This errata sheet provides updated information on Stratix™ devices. This document addresses known issues and includes methods to work around the issues.

Table 1 shows these issues and which Stratix devices each issue affects.

Figure 2. Gated Lock in Internal Logic Circuit

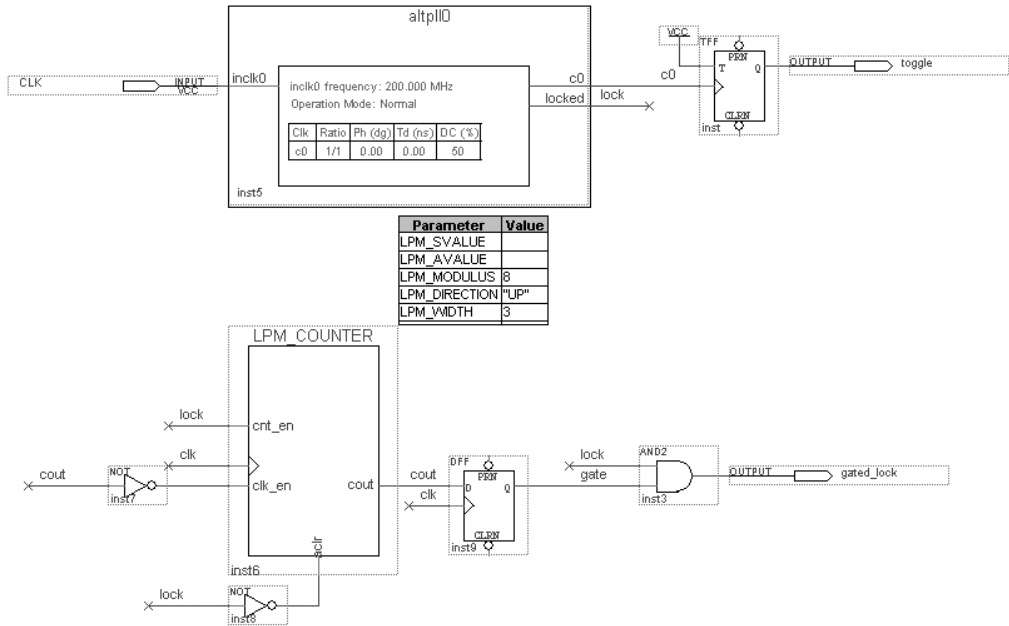
There is a run-through problem in the GLOCK counter that causes the counter to operate incorrectly. Support for the `gated_lock` circuitry was disabled in the Quartus II software version 2.1. Therefore, the `gated_lock` feature is unavailable in Stratix devices.

The work around for this problem is to gate the `lock` signal in internal logic. Altera recommends using a two-input AND gate to gate the `lock` signal with a counter. The number of bits in the counter (`LPM_WIDTH`) can be adjusted to control how many clock cycles before the `gated_lock` signal is released. The counter width in the reference design is currently 3. See Figure 2.

Figure 3. Gated Lock Signal Simulation Waveform

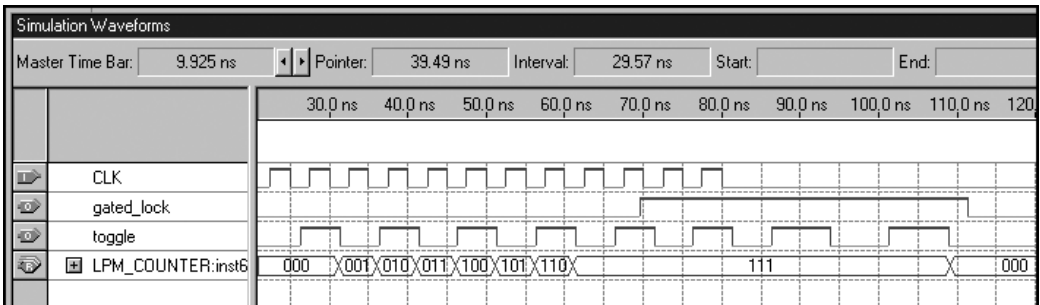
Figure 3 shows the simulation waveform of the gated lock signal. The gated_lock signal transitions high on the 10th clock cycle and is driven low after the PLL loses lock. The toggle signal frequency decreases as the V_{CO} frequency of the PLL begins to drift.

Figure 4. Clock Switchover Circuit

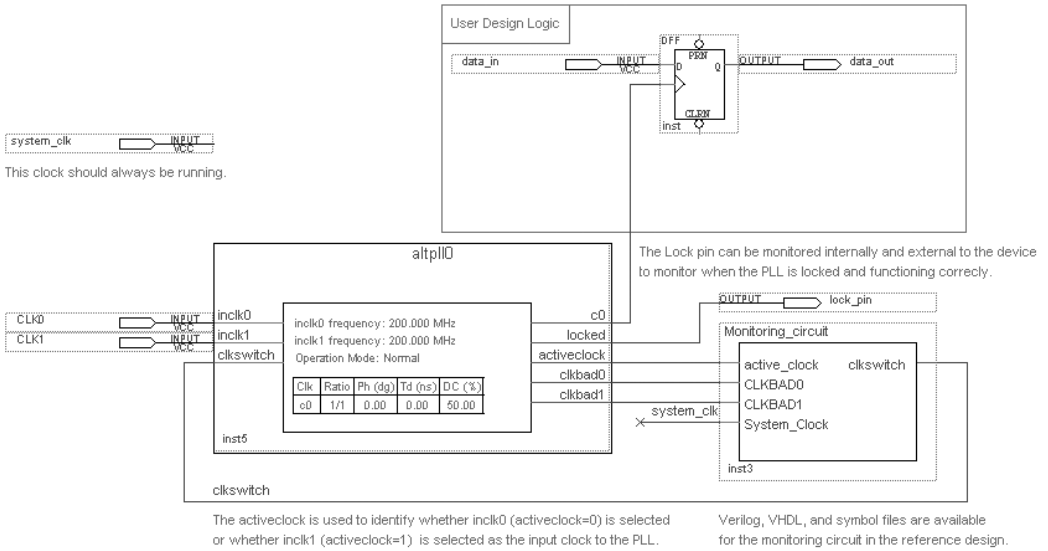
The CLKBAD0 and CLKBAD1 signals have a design flaw that cause a glitch on the signals. The glitches last for up to a half clock cycle of the input clock to the PLL. To prevent switchover from happening prematurely, a monitoring circuit is used to require the CLKBAD signal for the selected clock to be high for four consecutive system clock cycles before the PLL will switchover to the other clock.

To work around this issue, designers need to use the monitoring circuit as shown in Figure 4 when designing for clock switchover. The monitoring circuit watches CLKBAD0, CLKBAD1, and the `activeclock` signals from the PLL. The monitoring circuit switches the PLL from `inclk0` to `inclk1` when CLKBAD0 is detected for four consecutive system clock cycles; the monitoring circuit switches the PLL back from `inclk1` to `inclk0` when CLKBAD1 is detected for four consecutive system clock cycles.

In the circuit shown in Figure 4, CLK0 is the primary clock and CLK1 is the secondary clock. The `locked` signal can be used in the core and external to the device for monitoring the lock status of the PLL. The ALTPLL megafunction also has a `clkloss` output signal that can be monitored to determine when the clock switchover circuit initiates. `clkloss` goes high when the input clock is lost. If the primary clock fails and the secondary clock is not available, the clock switchover circuit continues to wait for a good secondary clock. The `activeclock` signal can be used in the core and external to the device for monitoring whether `inclk0` or `inclk1` is selected as the input clock to the PLL. A system clock that is guaranteed to be running at all times after the Stratix device is configured should be used to clock the monitoring circuit. Verilog HDL, VHDL, and schematic files are available in the reference design. It also contains waveform simulation and Verilog HDL and VHDL test bench files.

Figure 5. Simulation Results of Switchover Event

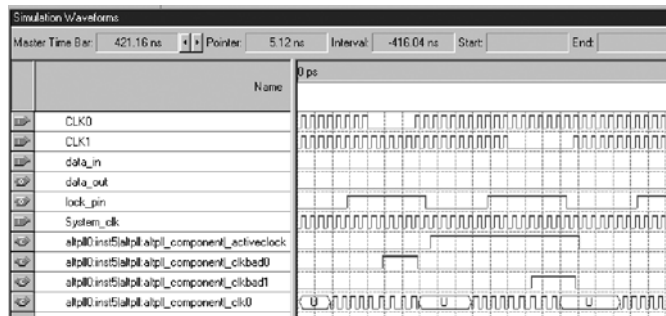
Figure 5 shows the simulation waveform of the PLL switching events. When CLKBAD0 is high for four consecutive system clock cycles, the PLL switches to CLK1 as the primary clock. After CLKBAD1 is high for 4 consecutive system clock cycles, the PLL switches back to CLK0 as the primary clock.
